Assessment Officer Report

PA2403256 – 79 Balwyn
Road, Balwyn.
Fintona Girls School

Officer Assessment Report
Development Approvals & Design

Department
of Transport
and Planning

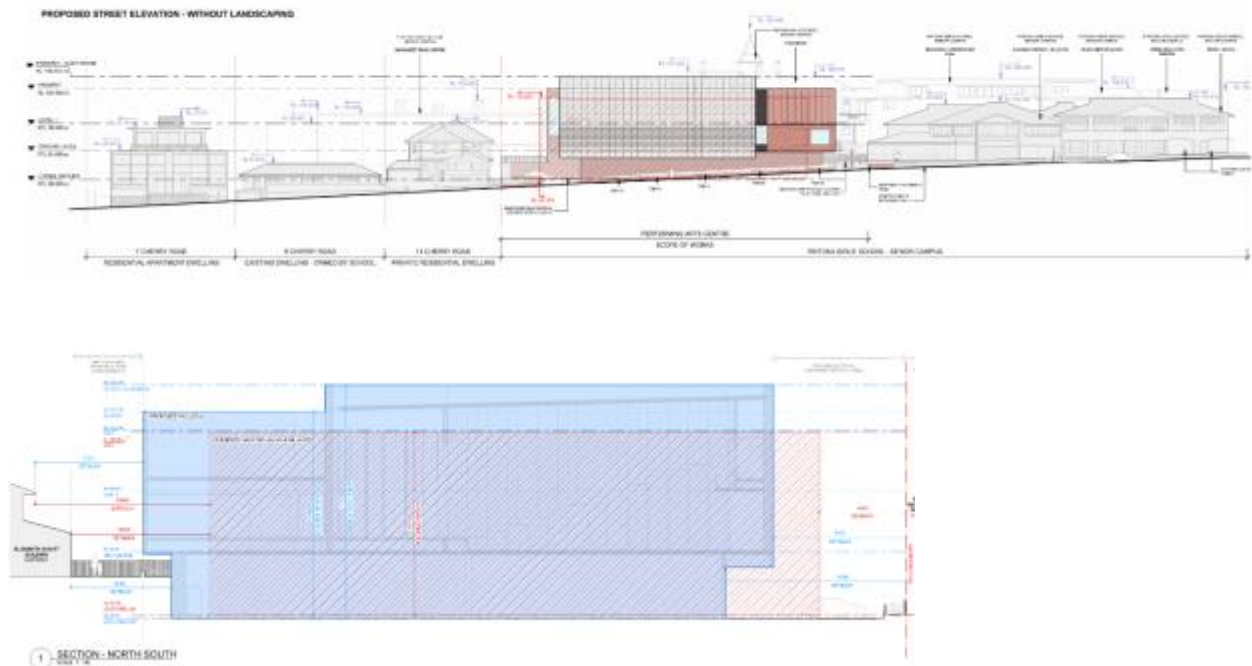
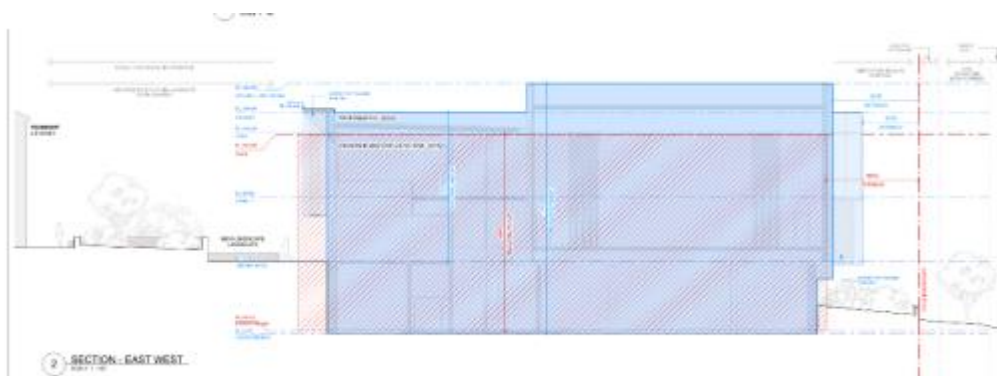
Key aspects of the proposal which are not consistent with the endorsed Development Plan include:

- 1. Overall building height exceeds the endorsed building envelope.*
- 2. The building extends outside the endorsed building envelope, particularly to the streetscape where the setback is reduced from 6.5 metres to 3.9 metres.*

1. We appreciate that the endorsed master plan provides indicative building envelopes for future buildings and accept the proposition that some deviation from the master plan parameters may occur during the development of the detailed design stage. However, any such variations should not change the building heights or setbacks, especially to the street, in a manner that will intensify the visual bulk anticipated in the master plan. Indeed, the approved building envelope offers the overall outline within which the final design product should sit comfortably, carefully responding to the streetscape character, subdivision pattern, grain, rhythm and proportions.

2. In response to the issues we raised at the pre-application meeting, the applicants have now provided a streetscape elevation, see below, with the proposed Performance Arts Centre (PAC) superimposed to demonstrate the acceptability of the form in the street. The approved building envelope is marked in red hatching on the street elevation below. The built form appears to be stretching out in some areas while retreating and pulling back in others. While the north-south cross section indicates increased setbacks to the north - an improvement to the interface with the northern neighbour, the east-west cross section shows a reduction in the setbacks to the street. It may seem that it is a mere half a metre reduction in the auditorium setback - from 6.50m to 6m, the combined visual impact of the reduced setback, increased height and raw

geometric/box-like form will be stark and formidable in the Cheery Road streetscape.

3. In response to the concerns we raised regarding the Cherry Road interface, the architects have made the following design improvements:
 - a. Enhancing façade articulation and visual interest at street level by adding the hit-and-miss brickwork, which should provide interaction and engagement with the public realm, plus improving safety since some light will spill out onto the street at night.
 - b. Adding some variation in the tone and patterning of the ceramic tiles of the upper levels (the Auditorium) to soften the apparent mass.
 - c. Extending the hit-and-miss brickwork to the side along the pedestrian entrance and walkway and adding a few openings in other locations., as evident in the views below.

- 
4. As the above 3D renders illustrate, these refinements have improved the scheme visually, offering opportunities for engagement and interaction with the street and main pedestrian pathway. In its effort to give back to the neighbourhood and community, the proposal also includes some bench seating for the public to use, integrated with the brick planter boxes along the footpath, a positive contribution.

Figure 19: Variation of PAC to approve master plan

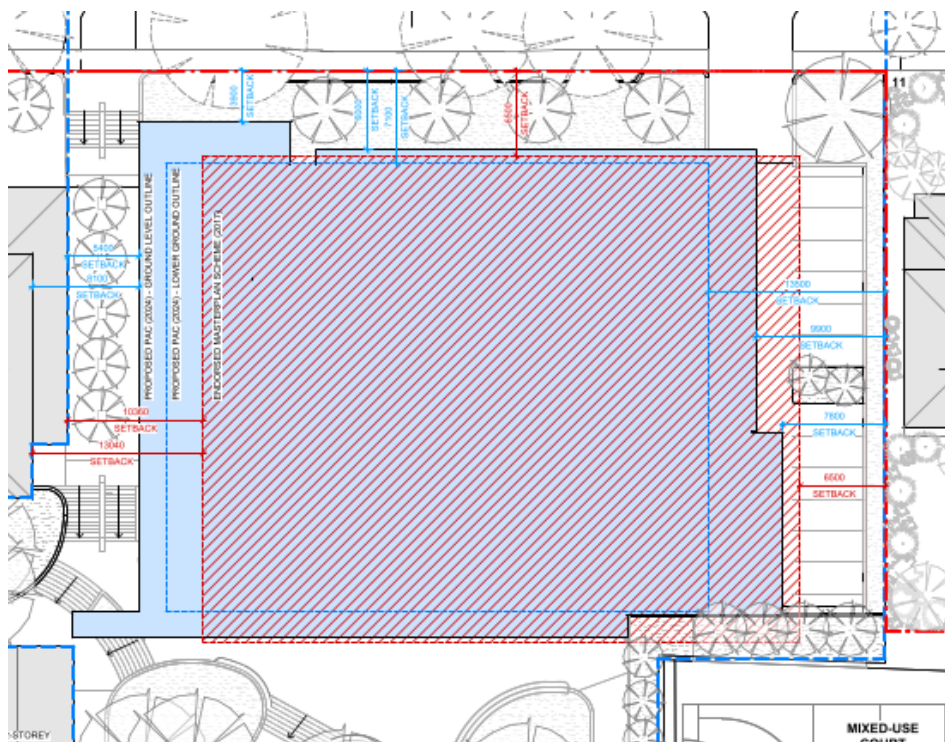
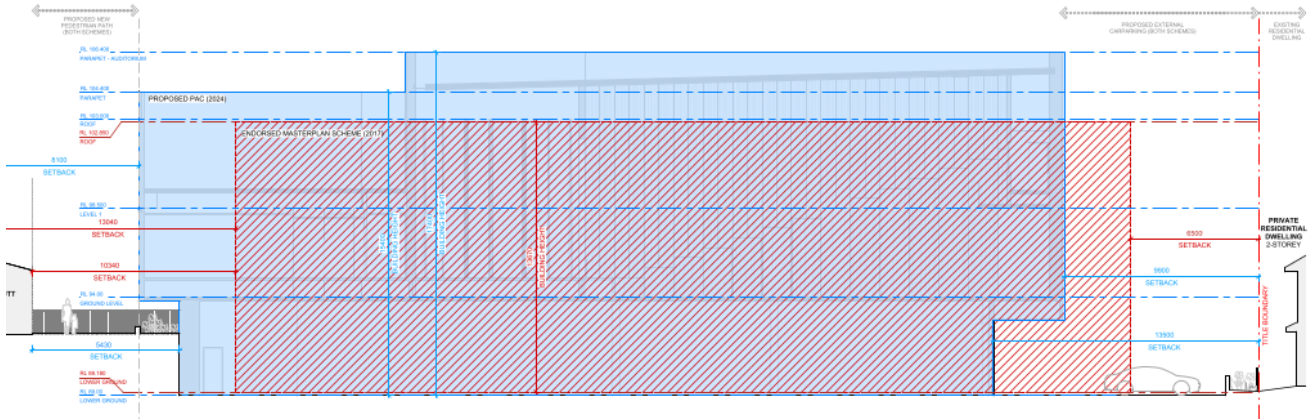
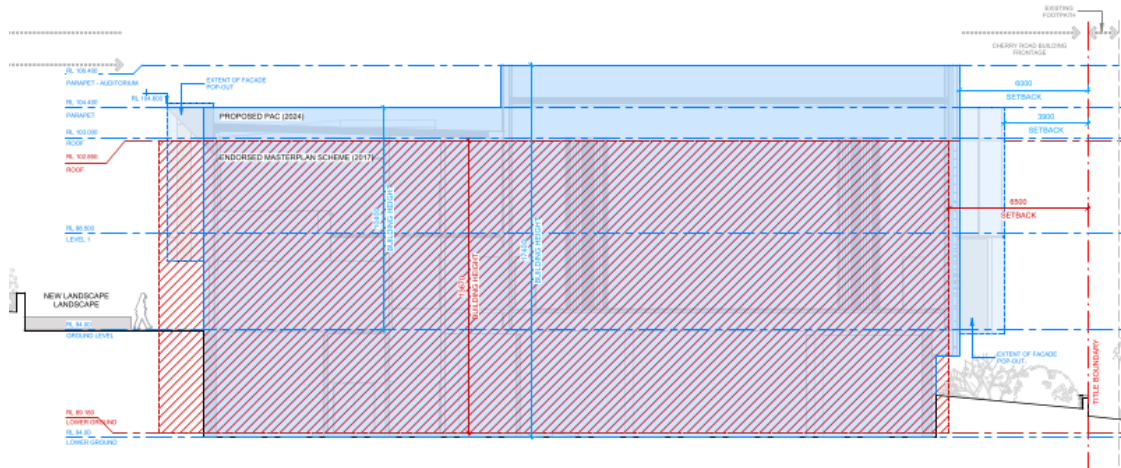
56. There is significant fall across the site from south to north, resulting in a higher built form along the northern elevation. This has been addressed through the use of increased setbacks and a staggered built form. Although the built form exceeds the height of the approved building envelope by 3.7m, it is acknowledged that the master plan provided for a similar sized building and the proposal is generally in accordance with what was approved.

60. The approved master plan allowed for a building height of 13.6m from lower ground, not taking into account the fall across the block of land.
61. To address the increase in height of the building, the design has increased setbacks to the dwelling located along the northern boundary. The approved building envelope proposed a 6.5m setback along the entire northern boundary with adjoining residence. The updated design has increased the setback to a minimum of 7.8m and a maximum of 9.9m.

89. While it is acknowledged that minor variations to the proposed built form which sit outside of the approved building envelope of the Master Plan are sought, the setbacks to the only residential interface located to the north, have been significantly increased from the approved building envelope. Setbacks to the north have been increased from 6.5m approved under the Development Plan to staggered setbacks of 7.8m – 13.5m.

90. The variation to the front setback as envisaged by the Master Plan is minor and can be supported. The front wall of the building is 49m in length with 38m of this frontage setback 6m in lieu of 6.5m and the remaining 11m of wall set back 3.9m in lieu of 6.5m. The smaller component of building with the 3.9m setback is adjacent to an existing school property which is not deemed as a sensitive interface, in addition, the western side of Cherry Road consists of parkland and has no residential interface.

Figure 22: Cherry Road Elevation

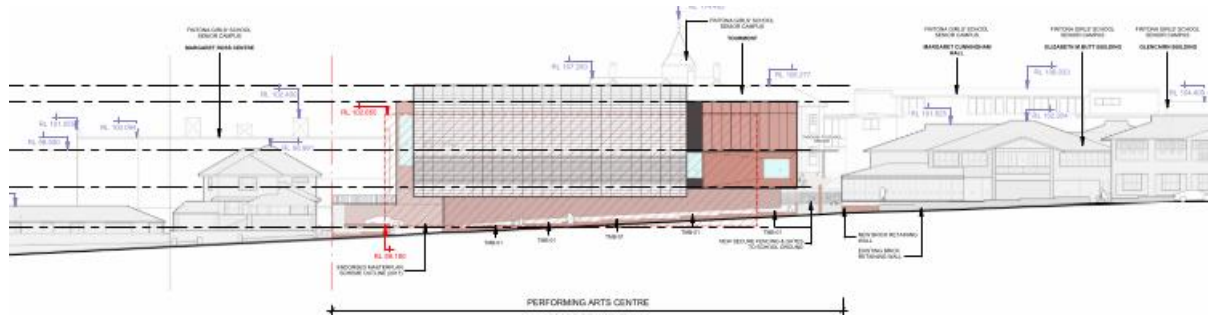
57. The proposal has a maximum building height of 17.4m to the top of the building on the northern end and a building height of 13.4m at the southern end due to the fall of the land.

58. The proposal is consistent in height with other new buildings on the school grounds and consistent with the heritage building located behind the new structure.
